Technical Memorandum

To:	Dale Ortman, P.E.	Date:	April 30, 2010
cc:	Tom Furgason, SWCA File, SRK	From:	Mike Sieber, P.E, SRK Stephen Day, P.Geo. SRK Vladimir Ugorets, PhD, SRK
Subject:	Technical Review of <i>Infiltration, Seepage, Fate and Transport Modeling Report</i> , Tetra Tech, 2010, Prepared for Rosemont Copper Company	Project #:	183101

Figure 1 Example of soil water characteristic curve (SWCC)

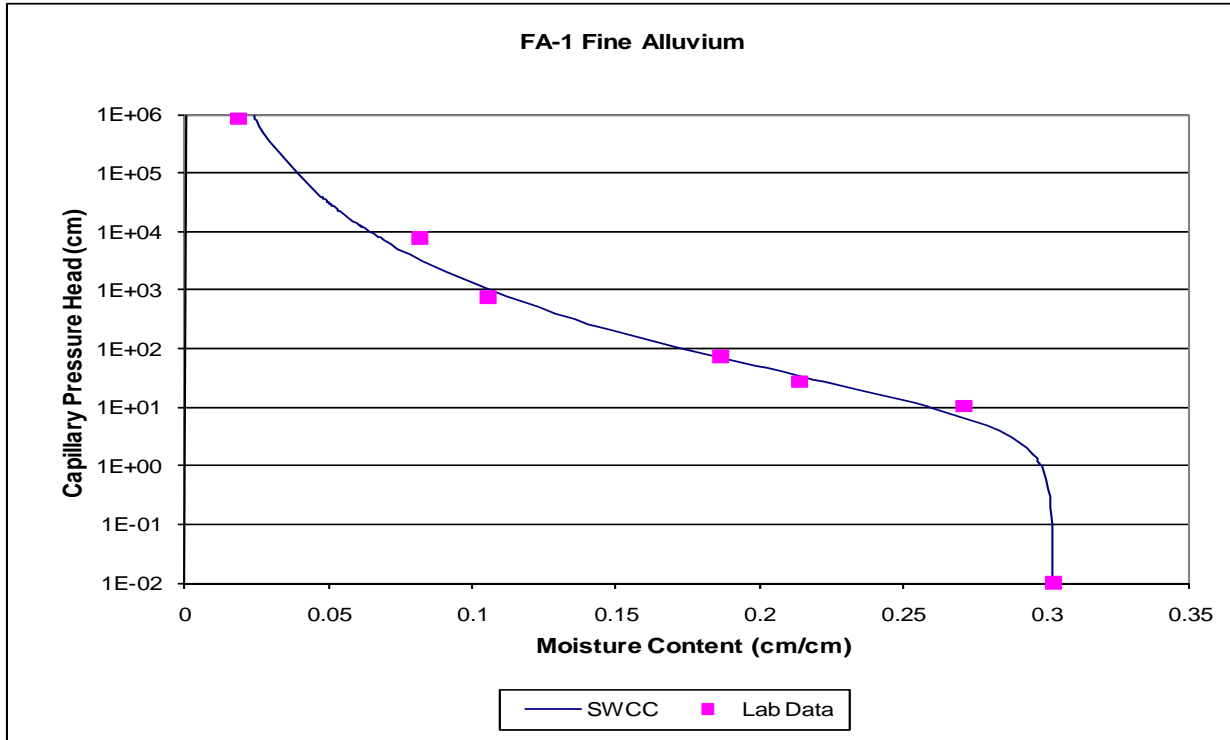
Section 5.3 of the report provides an explanation of unsaturated flow theory. Illustration 5.5 shows a generic soil water characteristic curve (SWCC) for two soils, however, an illustration of hydraulic conductivity as a function of capillary function or moisture content is not presented or discussed. Section 5.5.5 presents saturated hydraulic conductivity values for three waste rock materials, alluvium, and bedrock without providing either a range of values, or a source for the saturated hydraulic conductivity data.

The conceptual model for the Waste Rock Storage Area shows three layers of waste rock, benches-buttrass, alluvial deposit, and bedrock, each with different properties. The model logs in Appendix C give a brief description of the material—Andesite—for unconsolidated waste rock and list the unsaturated properties. Section 5.5 state that laboratory and library parameters were used for unsaturated flow parameters. The laboratory work that was completed should include the data, laboratory name, and the ASTM methods that were used. The GEO-SLOPE library data should also be presented. SWCC and unsaturated hydraulic conductivity charts for the materials modeled should be presented in either the report or appendices. The charts in Figure 1 and Figure 2 below are examples of what is necessary to present a defensible infiltration-seepage model. In Appendix A, AMEC presented the SWCCs and a hydraulic conductivity function for the Dry Stack Tailings Storage Facility infiltration and seepage model.

- Present SWCC and unsaturated hydraulic conductivity functions on charts for all of the waste material and the alluvial deposit and bedrock.
- The Heap Leach Facility draindown model should use material typical of leached oxide ore. Alternatively, a review of actual draindown data from similar closed heap leach facilities could be considered.
